PROJECT NAME: MSP PID 8009-1274-19

PROJECT NUMBER: 2025060058

APPLICATION: MINOR SITE PLAN #32991

No.	REVISION	DATE	APPROVED:	MCA	CHECK:	MCA	FILEP: BELAC MSP		
			SCALE	AS SHOWN	DRAW:	WS	JOB NUMBER:	25-041	C002
			DATE:	6-17-25	DESIGN:	MCA	PROJ. BELAC MSP		SHEET
					OCAL	A, FL	ORIDA		
			1				Y, FLORIDA 7. RGE 21		
							74-19		
							UPLEX		
			MINOR	SHE	PLAN	_	LANDSCA	PE PL	AIN.

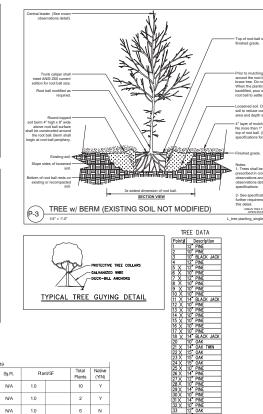
REMARKS: Show tree protection for trees to be preserved on plan and in detail

,	
		MINOR	SITE	PLAN	۱ –	IRRIGATIO	N PL	AN
						UPLEX		
						74-19		
			MAR	ION CO	OUNT WP 1	Y, FLORIDA 7, RGE 21		
				OCAL	LA, FL	DRÍDA		
		DATE:	6-17-25	DESIGN:	MCA	PROJ. BELAC MSP		SHEET
		SCALE:	AS SHOWN	DRAW:	MS	JOB NUMBER:	25-041	C003
REVISION	DATE	APPROVED:	MCA	CHECK:	MCA	FILEP: BELAC MSP

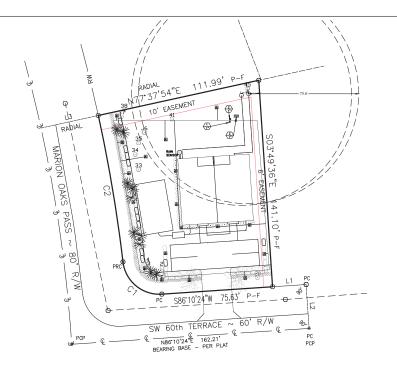
REMARKS: Sheet C001 has STR as 08-17-21 under the aerial map graphic scale, it should be Sections 08 & 17. Sheets C001, C002, & C003 have the STR as 08-17-21 in the title bar, it should be Sections 08 & 17. Please update on all applicable sheets.
